APPLICATION NO.	FILING DATE	FIRST NAMED INVENTOR	ATTORNEY DOCKET NO.	CONFIRMATION NO.
10/776,541	02/10/2004	Amir Morad	13757US03	3126
23446 7590 06/30/2009 MCANDREWS HELD & MALLOY, LTD 500 WEST MADISON STREET SUITE 3400 CHICAGO, IL 60661				
EXAMINER				
VO, TUNG T				
ART UNIT		PAPER NUMBER		
2621				
MAIL DATE		DELIVERY MODE		
06/30/2009		PAPER

Office Action Summary

DETAILED ACTION

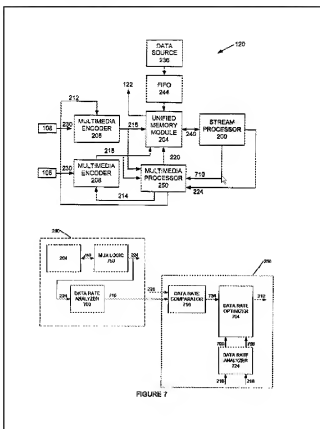
Hinchley discloses multiplexer circuitry (200 of fig. 2, note the stream processor, 200 of fig. 2, comprises the MUX LOGIC (750 of fig. 7) is compliant with MPEG2 standard, which has the same functions as multiplexing circuitry as disclosed above of the present invention) that operates in a first mode and a second mode (MUX logic (750 of fig. 7) performs multiplexing operations that encompass a first mode and second mode). Since Hinchley discloses the MUX logic (750 of fig. 7) have multiplexing operations as modes with recognized standards such as MPEG2, col. 6, lines 12-26, so the MUX logic performs when operating in the first mode produces a first multiplexed stream from first compressed video, first compressed audio, second compressed video, and second compressed audio; and when operating in the second mode concurrently produces the first multiplexed stream from the first compressed video and the first compressed audio, and produces a second multiplexed stream from the second compressed video and the second compressed audio, which is the same the multiplexing circuitry, 114 of fig. 5, of the present invention as disclosed in the specification, [0040], [0061], [0063], and [0064].

Let compare the multiplexing circuit of Hinchley and the present invention as follows:

Based upon the comparison above, Hinchley's MUX logic (750 of fig. 7) has the same functions (MPEG2 standards) as Multiplexing processor (114 of fig. 5) of the present invention. Therefore, Hinchley clearly anticipates the claimed features.
